**SB-GA8-2008-47**

**Issue 4**

## Service Bulletin

Fuselage Skin Wear at Stabiliser Lower Fairing.

**Figure 1: Wear strip location**

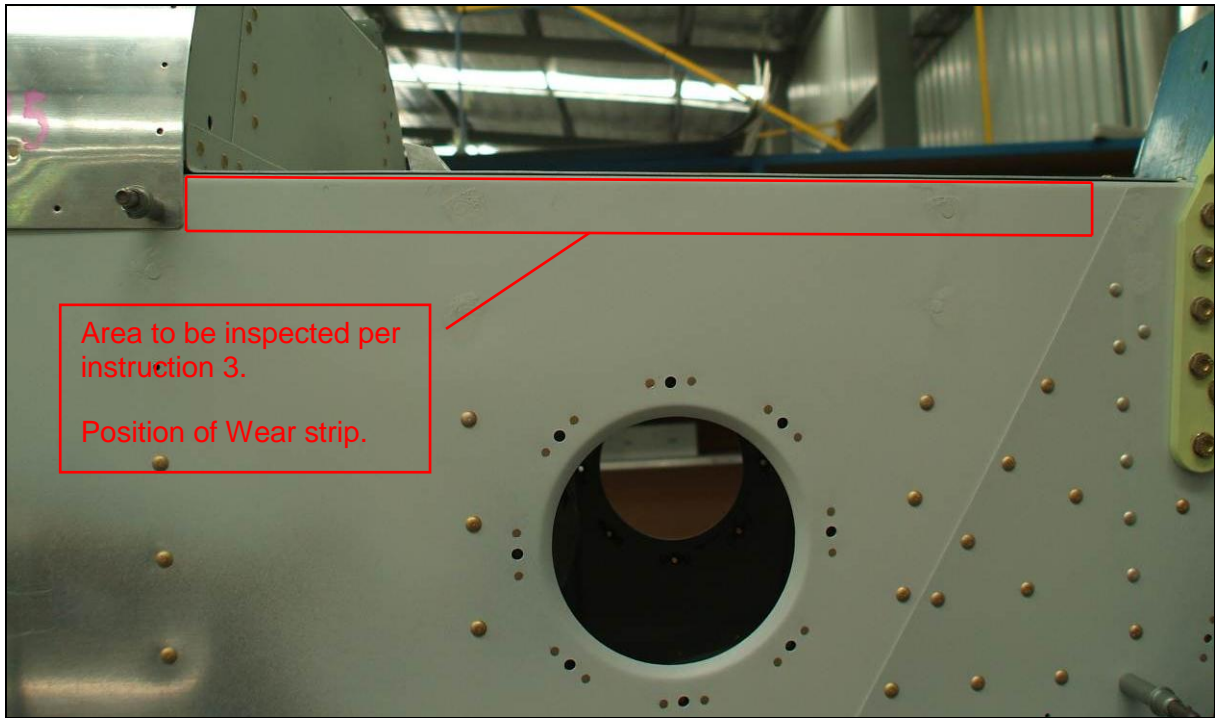
3. Clean and inspect the area shown in Figure 1 for any signs of wear. If the fuselage skin shows signs of wear other than removal of the paint finish or scuffing to the surface of the metal, or contains a crack that is no greater than 6" in length, implement the Repair Scheme defined below. If damage exceeds this amount contact GippsAero Pty. Ltd. with full details.

4. If no wear is present, position the two wear strips, GA8-538021-335, over the area shown in Figure 1 (LH side shown) and retain in position with adhesive tape. Mark the position of the holes then drill to 3/32-inch, clean and de-burr these holes. Prepare the area using a 240 Grade abrasive cloth then clean with a suitable solvent. Remove the protective strip from the back of each wear strip and apply a thin coating of 164G00002, (Pro-Seal 34 or Hysol EA9394 may be used as alternatives) to the back of each strip. Attach the strips using the MS20426AD3-4 countersunk rivets supplied. Ensure the strips are pressed firmly against the skin and that the wear strip remains flat. Remove any excess sealant. Adhesive tape or appropriate clamps may be used to hold the strips firmly in position until the sealant has properly cured.

**Figure 2: Tinnerman Plate positions**

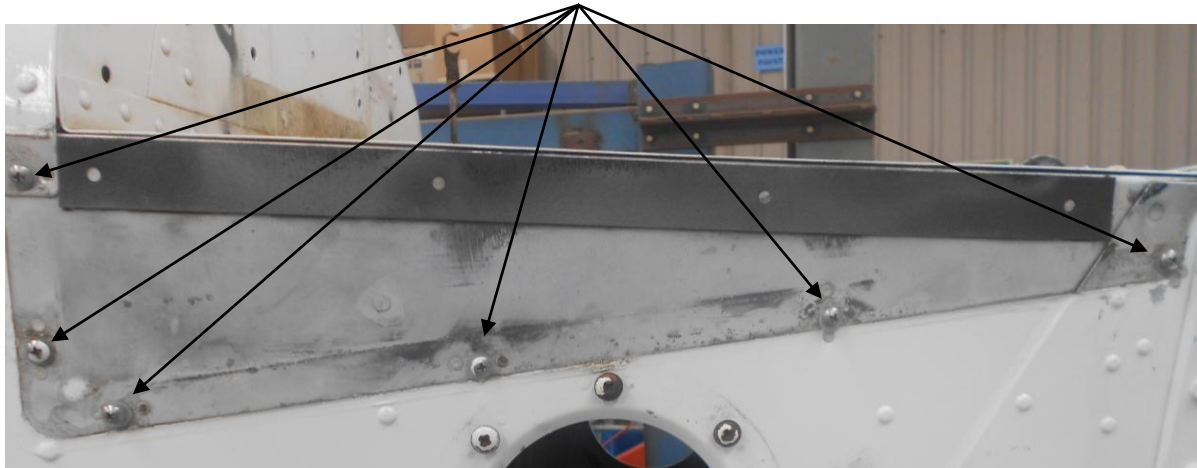
5. Install six 412G00004 anchor nuts with NAS1097 rivets to each side of the fuselage (Figure 2 & 3) and install the new covers, left - GA8-538022-017 and right - GA8-538022-018 using the 418G00013 Screws and NAS1515H06L washers.

**Figure A:** Inspection hole stiffener rivets

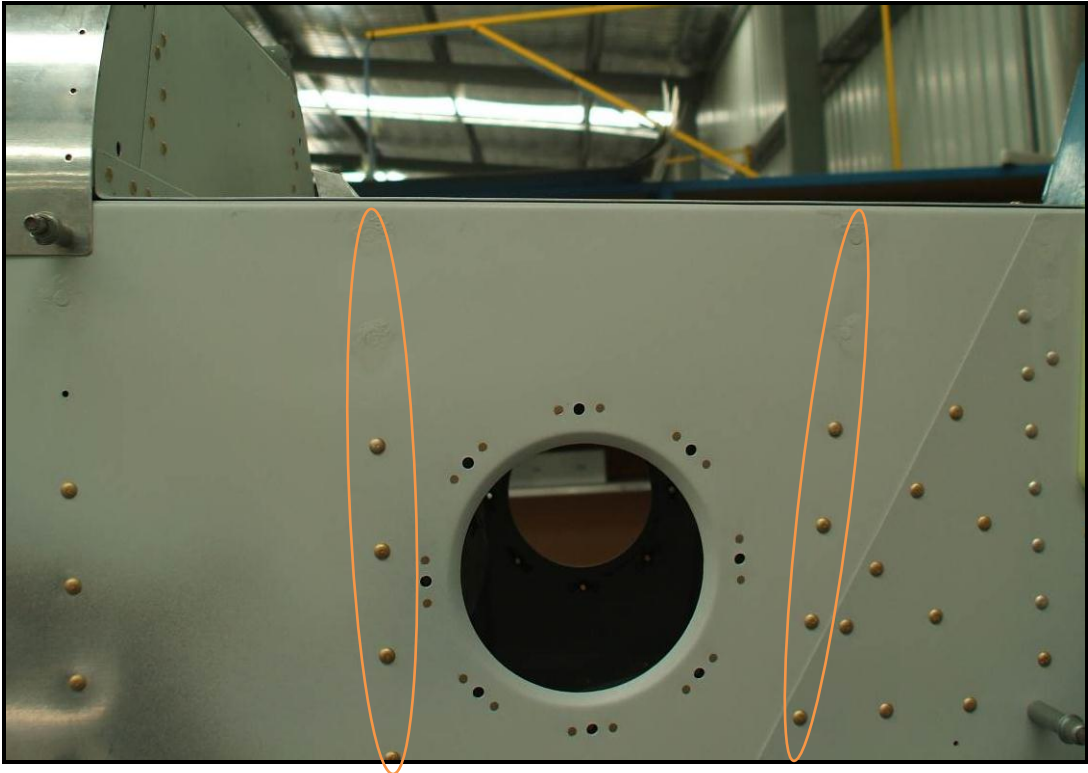
- A. If cracking exists, stop drill crack tip at both ends with 3/32" inch dia drill and deburr to prevent further crack propagation.
- B. Manufacture a repair doubler from 0.025 inch thick Alclad 2024-T3 sheet. Cut out a 15.25" x 3.6" flat pattern; bend through 90 degrees to form an L-section with equal flange lengths. Deburr and remove all sharp edges.
- C. Manufacture a 9" x 0.75" flat packer and a 7" x 0.75" flat packer from 0.025 inch thick Alclad 2024-T3 sheet. Deburr and remove all sharp edges.
- D. Drill out rivets that attach the fwd and aft inspection hole stiffeners adjacent to the cracked/worn area (Ref Figure A, B, C).
  - a. GA8-538021-221 FORWARD INSPECTION HOLE STIFFENER
  - b. GA8-538021-223 AFT INSPECTION HOLE STIFFENER

**Figure B:** Fwd stiffener

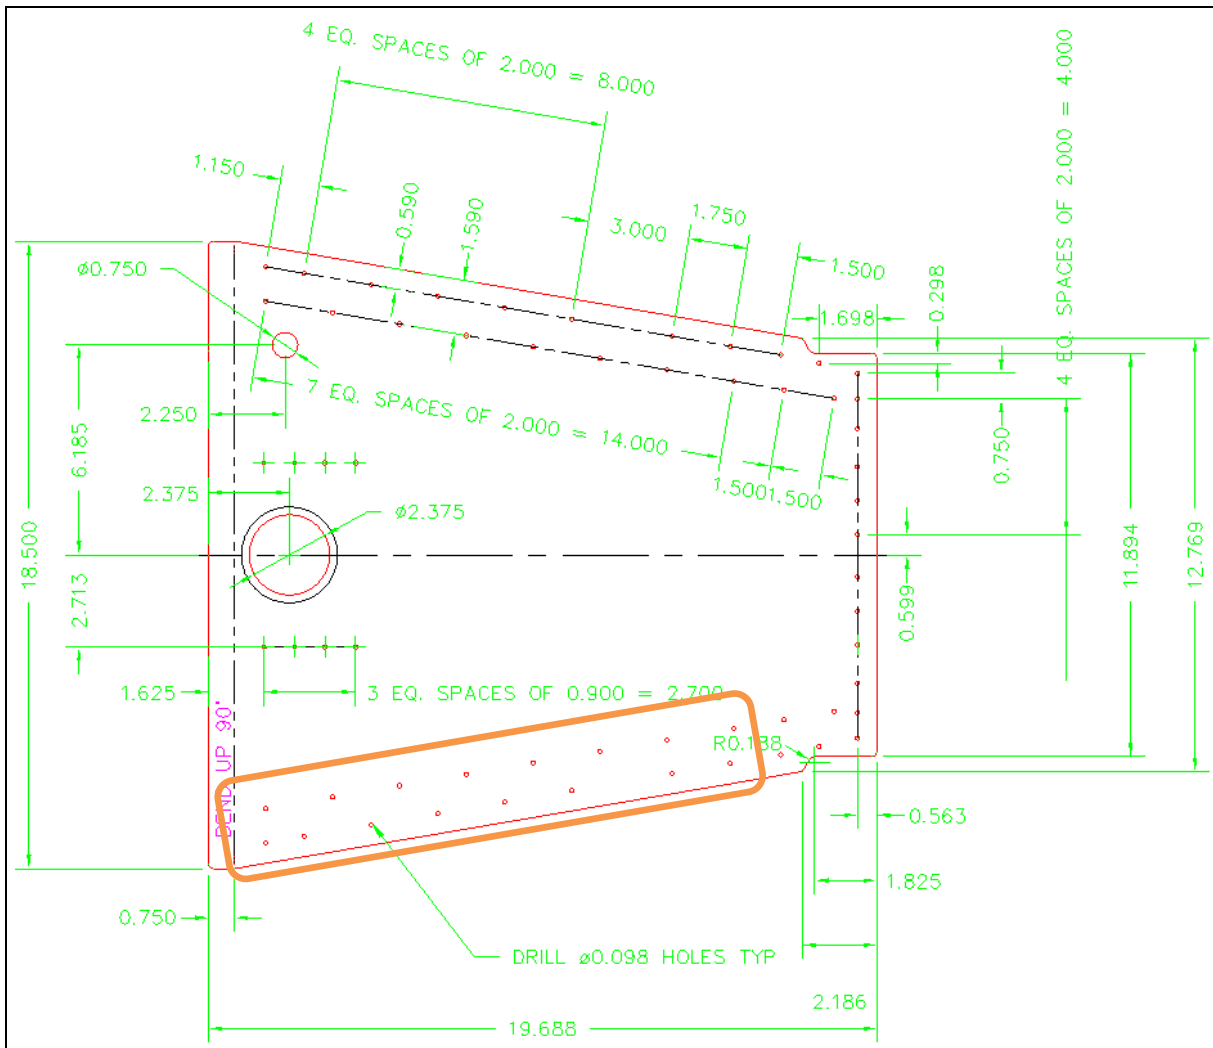
- L. Re-install forward and aft inspection hole stiffeners with packers underneath to avoid clash with doubler. Rivet length to be determined on assembly.
